UNITED STATES PATENT AND TRADEMARK OFFICE

Office Action Summary	Application No. 10/789,268	Applicant(s) STAGER, BRADLEY R.	
	Examiner Bena Miller	Art Unit 3725

DETAILED ACTION

Figure 4 of Bachmann

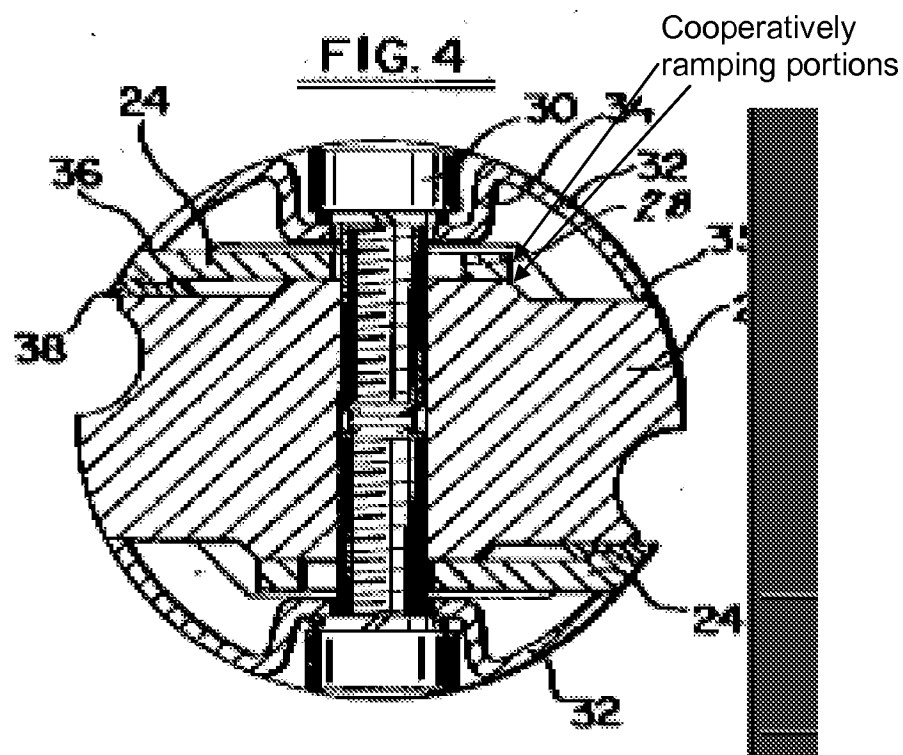
Claims 1, 5, 19, 27 and 29 are rejected under 35 U.S.C. 102(b) as being anticipated by Bachmann (US Patent 4,347,882).

The device Bachmann teaches the elements of the claimed invention including:

a dual cutting edge knife having spaced-apart first and second sides defining a thickness of the knife (38);

a base (32);

a wearshoe (22);

an upper clamping member (24), said wearshoe for mounting to side of said base and said upper clamping member for mounting to one the other side of said base such that a first portion of said upper clamping member, corresponding to said first side of the knife, extends cantilevered (col. 4, par. 1) over a corresponding second portion of said wearshoe, corresponding to said second side of the knife, so as to define a gap between said portions that is greater than said thickness, for receiving the knife in a first configuration of the apparatus in which the knife is not clamped between said a gap reducing mechanism for elastically deflecting said first portion in the direction of said second portion so as to define a second configuration of the apparatus for clamping the knife in which said gap is reduced sufficiently to conform to said thickness, cooperatively ramping portions (see marked copy figure 4 of Bachmann below; Note, the examiner takes the position that the ramping portions define an angle of 5°) and at least one bolt (30).
